**CITY OF EL PASO, TEXAS
AGENDA ITEM
DEPARTMENT HEAD'S SUMMARY FORM**

That the City Council approves a Change Order in the amount of \$321,487.00 to Hensel Phelps Construction Co. (Contractor) for the furnishing and installation of Class A fire rated felt panel above the new linear plank ceiling to meet NFPA 13 code requirements for the EPIA Terminal Ceiling and Lighting Improvements Project, Contract No. 2023-0199. There is no change in the contract time resulting from this Change Order. The new contract sum, including this Change Order notice and any previous change order notices, is \$10,145,074.00. The City Manager, or designee, is authorized to execute any documents and contract amendments needed to carry out the intent of this Resolution.

CITY OF EL PASO CONSTRUCTION CHANGE ORDER

ARCHITECT'S SUPPLEMENTAL INSTRUCTION NO: FOUR (4)

OPTION No. 1 - 1" LINEAR PLANK PANELW/ FELT PANEL

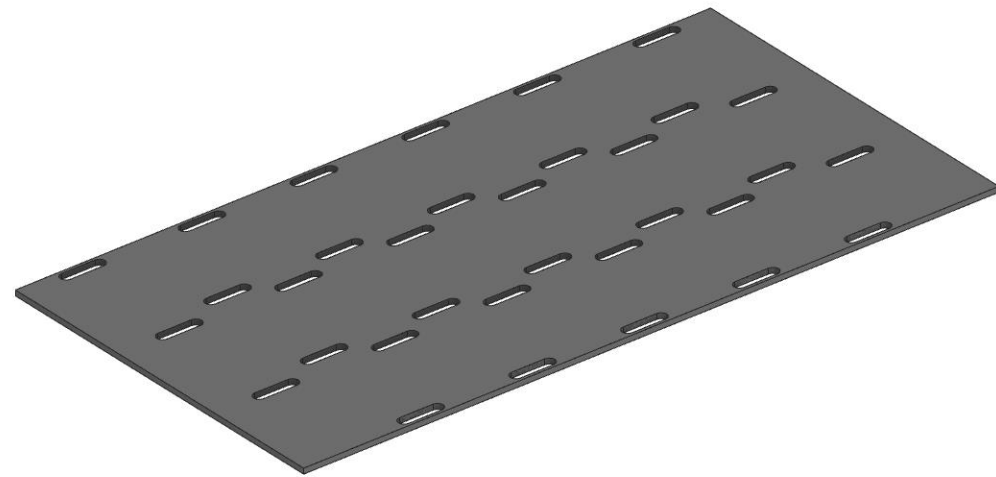
DESCRIPTION: The attached architectural details and Armstrong drawings shows option 1 for the Metal works IMMIX Linear plank panel with 9mm felt panel by Armstrong.

Narrative Description of Change SOW: As per the Architect's Supplemental Instruction No.4, the scope of work shall include furnishing an estimated 28,000 SF of an approved class A fire rated felt panel, installing the panel above all of the new linear plank ceiling system; quality control, equipment, labor, tools and other incidentals as needed to complete the scope of work.

New Drawings/Specifications Reference: Architectural Detail 1: Linear Plank Ceiling w/ Felt Panel dated 9/8/2023
